# UNITED STATES PATENT AND TRADEMARK OFFICE

APPLICATION NO.	FILING DATE	FIRST NAMED INVENTOR	ATTORNEY DOCKET NO.	CONFIRMATION NO.
10/523,155	01/27/2005	Petrus Adrianus Josephus Holten	NL 020713	8386

**Office Action Summary**

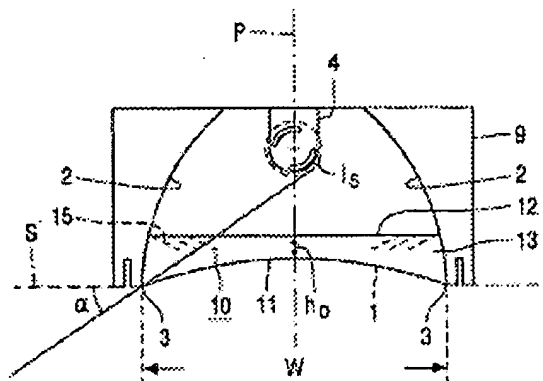
8. With regards to Independent Claim 6, the Applicant defines within the preamble and provides the scope to be confined to a lamellae louver, but recites in lines 5-6 the limitation, "a light-emission window", which renders indefiniteness and confusion. At present, "a light-emission window" is not a part of the lamellae louver, but rather should be a part of the luminaire. It is suggested that the above recitation should read as "a light-emission window of a luminaire", so as to elucidate that the lamella does not have a light-emission window.

10. The following is a statement of reasons for the indication of allowable subject matter: With regard to Independent Claims 1 and 6, the Applicant has sufficiently claimed and defined a lamellae louver, whereby the prior art fails to teach or suggest the combination of structural elements claimed therein, specifically to a distance  $h_0 < 0.1W$  or length of the lamellae (see drawing below), and all dependent claims are allowed.
